## **Nestlewood Solar – Response to Data Requests Received April 8, 2019**

**Attachment 1.**  
**Updated OPSB Application Figure 03-3 – Project Layout**

Nestlewood Solar  
Brown and Clermont Counties, Ohio

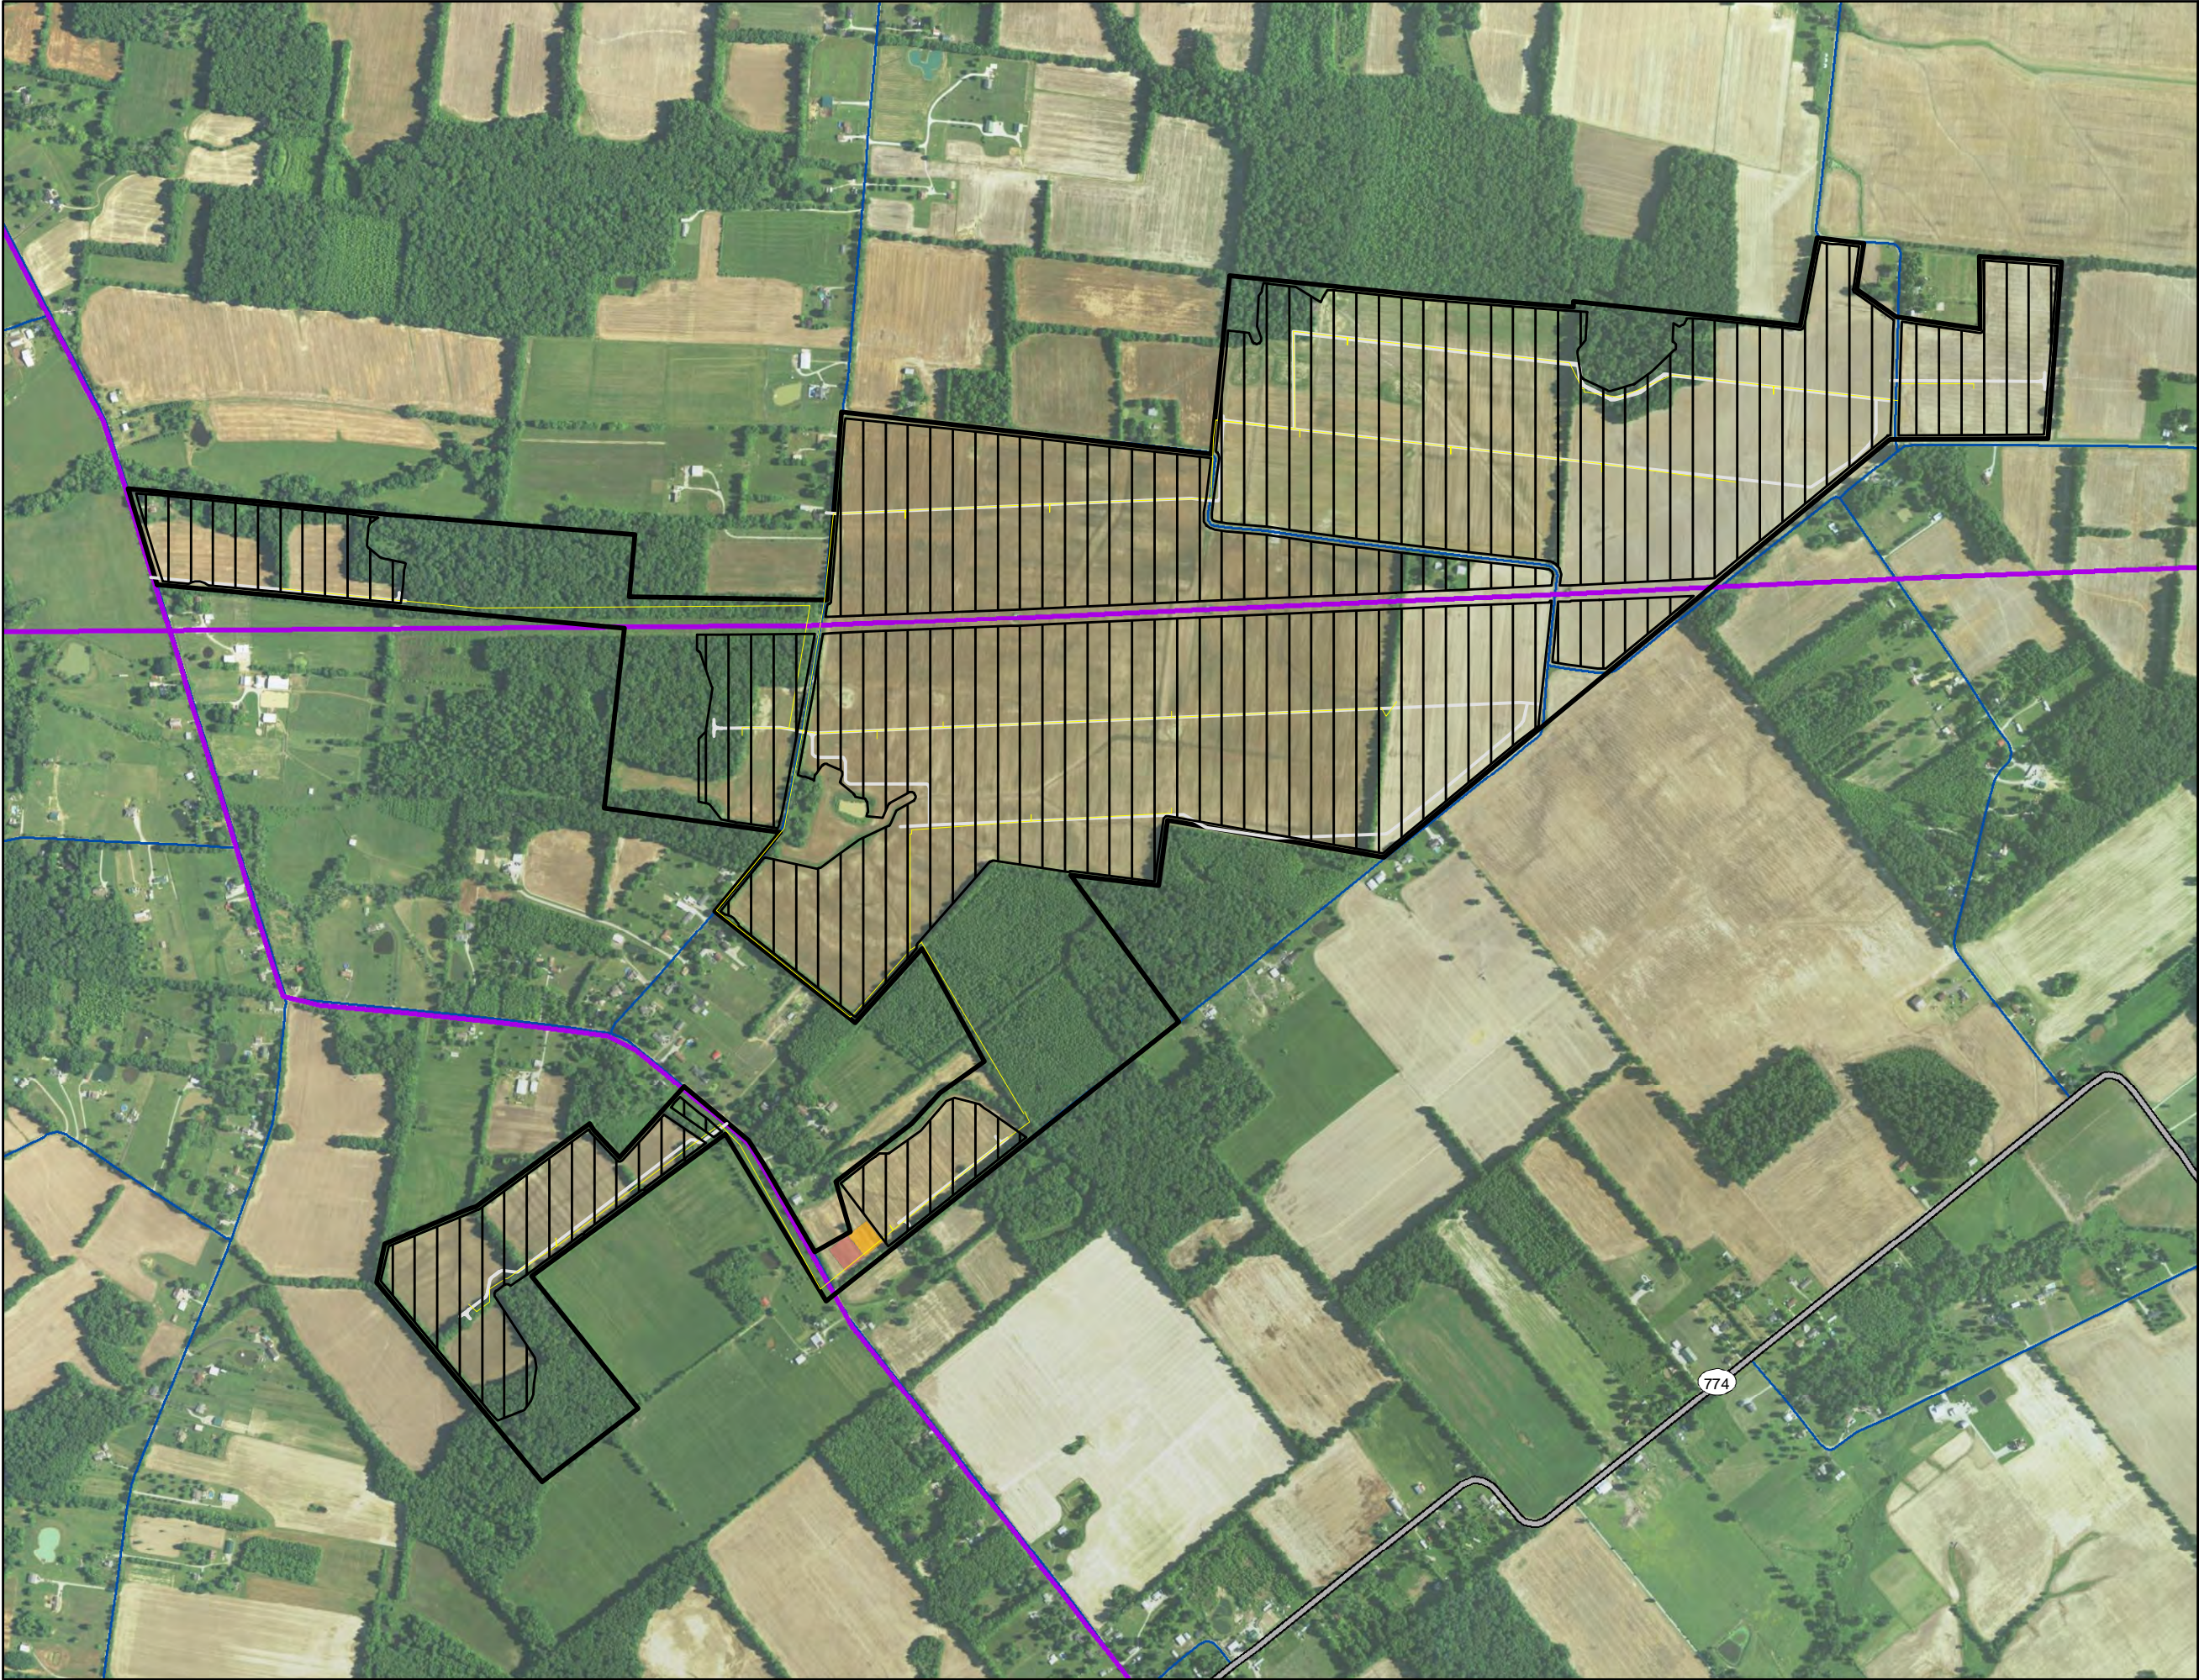
**10. Please provide a list of each vegetative community type in the project area and the proposed acreage of impacts to each.**

Vegetative community types were provided in the OPSB Application on Figure 08-9. Based upon the updated layout, the following reflects the approximate acreage of impact to each habitat type:

As can be seen, only minimal activity is proposed within wetland communities (less than 1% of the wetland communities present within the Project Area). Primary placement of potential solar arrays occurs in agricultural community (91.2% of the available agricultural land within the Project Area is identified for potential use). A small amount of developed land (27.8% of the developed land within the Project Area) will be potentially used. Of the forested areas located within the Project Area, 50.7% would be cleared or topped for installation of Project elements.

**Updated Figure 03-3  
Project Layout**

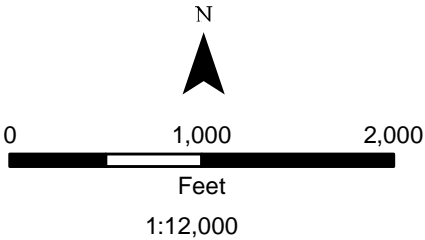
- 1. The Application stated that there would be no in-water work. However, GIS provided by the Applicant shows an access road crossing stream D. How does the applicant propose to avoid impacts associated with the proposed access road?***

- 2. GIS provided by the Applicant shows panels overlapping with stream A. Staff would recommend that no panels be located within streams. Please explain if the applicant would not find this recommendation to be reasonable or would otherwise dispute it. If no impacts are proposed to this stream, please explain how they would be avoided.***

- 3. GIS provided by the Applicant shows panels overlapping with wetlands w-9 and w-10. Wetlands located within the proposed array area make up less than one acre. Staff would recommend that no panels be located within wetlands. Please explain if the applicant would not find this recommendation to be reasonable or would otherwise dispute it.***

7. ***GIS provided by the Applicant shows collection line crossings of four wetlands, an access road crossing of one wetland, and potential panels located within two wetlands. Further the application states that tree clearing in wooded wetlands would be avoided, however, GIS data provided by the applicant shows tree clearing in wetlands w-3, w-6, w-7, and w-8. These impacts are generally along the edges of wetlands and seem that they could be avoided through slight adjustments. Are these adjustments reasonable and could these adjustments be accomplished without increasing other impacts? If yes, please supplement the application to reflect these adjustments. If no, please explain why. If any collection line adjustments cannot be made to avoid these impacts is HDD a feasible option to avoid tree clearing and open cut impacts within wetlands? If no, please explain why.***

The streams located throughout the Project Area intermittently carry water. Ideally, the Project will be able to schedule the single proposed culvert installations during the dry season. An updated layout drawing (provided as Attachment 1) illustrates the location where a culvert will be necessary. Typical culvert details are shown in Attachment 2. Impacts within the stream channel associated with culvert placement are expected to be approximately 1,700 square feet, considerably less than the 0.1-acre that would require a Pre-Construction Notice from the U. S. Army Corps of Engineers. The culvert will be designed to allow for carrying capacity of excess water during heavy rainfall events.

The proposed layout included in the OPSB Application was illustrated as intentionally broad to allow for design optimization. No panels will be located within streams, as reflected in the updated layout provided as Attachment 1.

No panels will be located in wetlands, as reflected in the updated layout provided as Attachment 1.

As reflected in the updated layout, presented as Attachment 1, the Project reflects one access road crossing of a stream, three collection line crossings of streams, and one collection line crossing of a wetland. Panels will be adjusted to avoid the wetlands. Wooded wetlands will not be cleared, and the Applicant has committed to maintaining a minimum 15-foot buffer surrounding wooded wetlands that will not be cleared.
